Platt Technical High School

ADDENDUM NO. 4

August 9, 2019

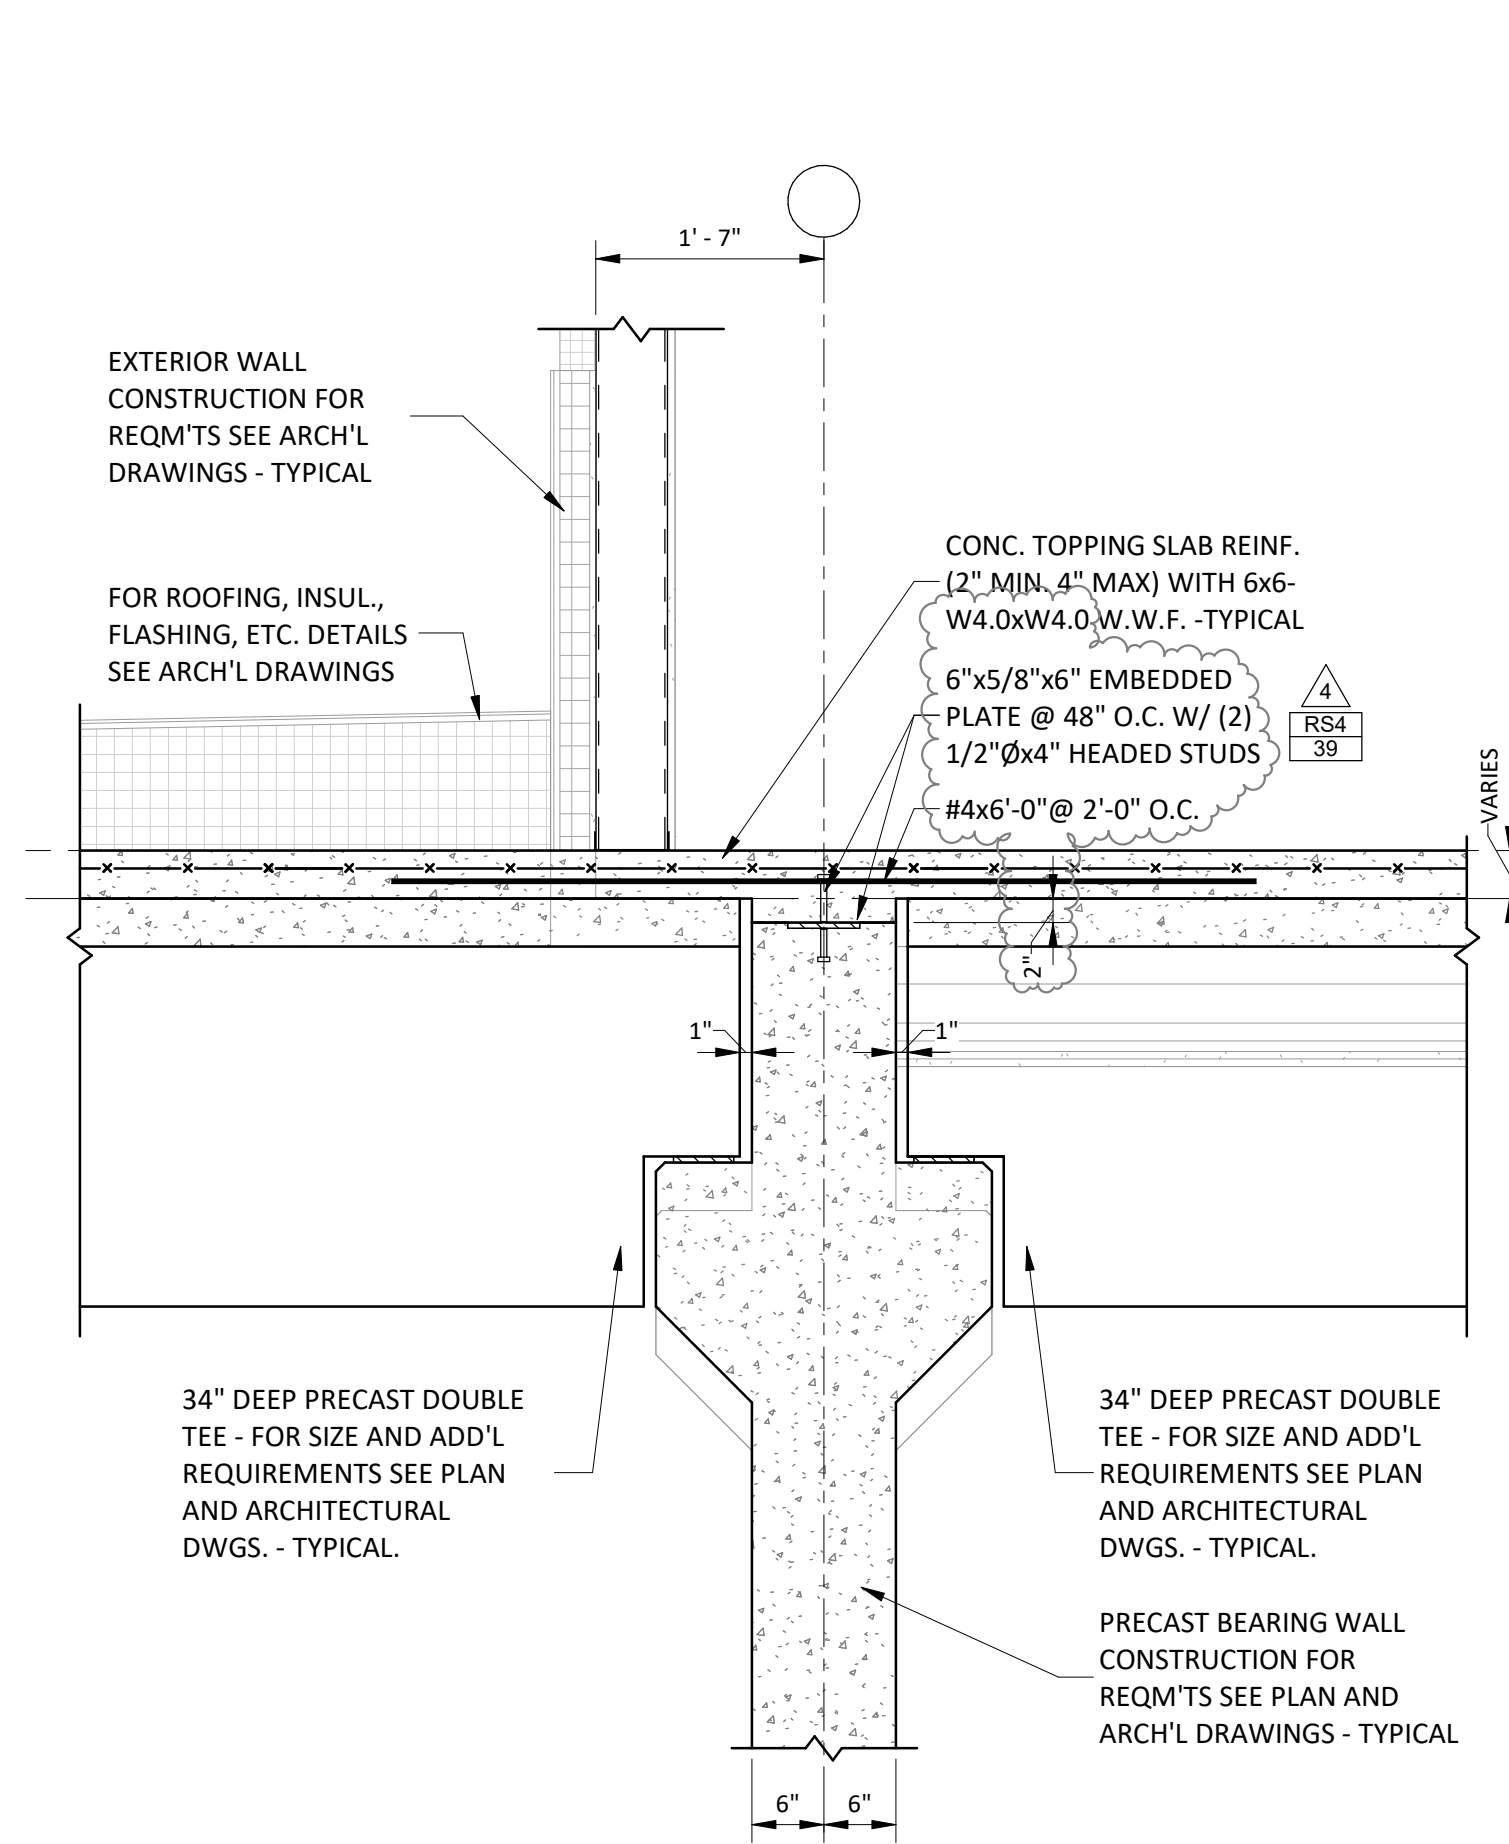
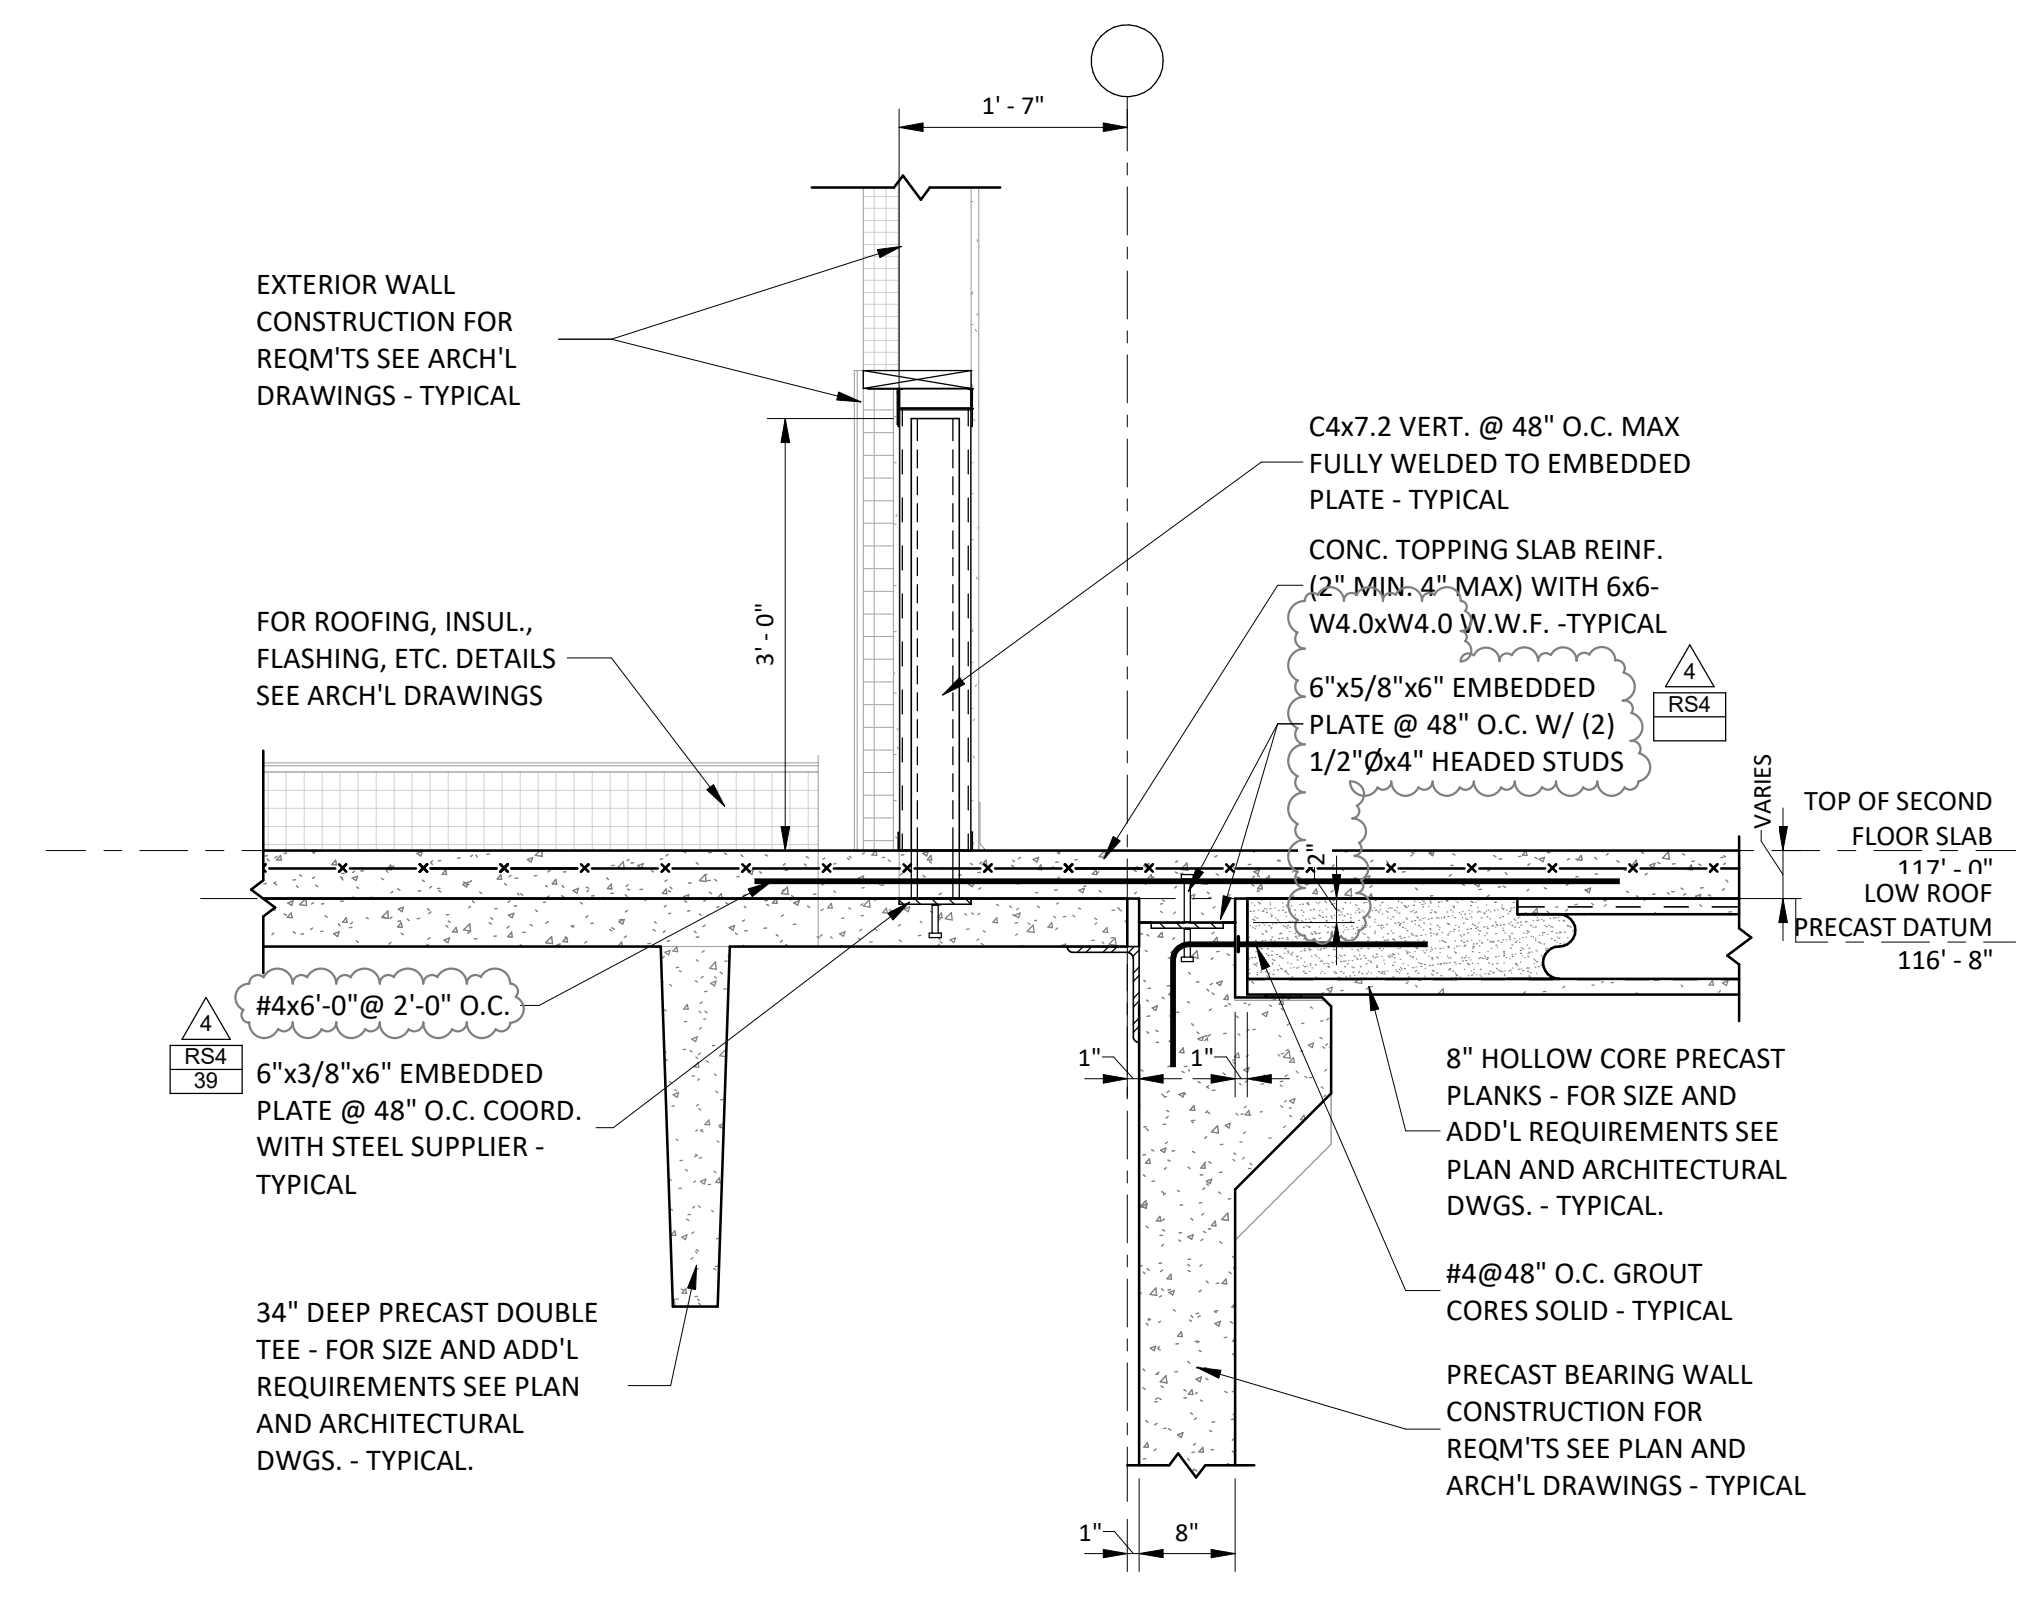
- ADD 4-130 DRAWING S5-2-1– STRUCTURAL SECTIONS**
Revise topping reinforcement per Revision RS4-39.
- ADD 4-131 DRAWING S5-2-2– STRUCTURAL SECTIONS**
Revise topping reinforcement per Revision RS4-40.
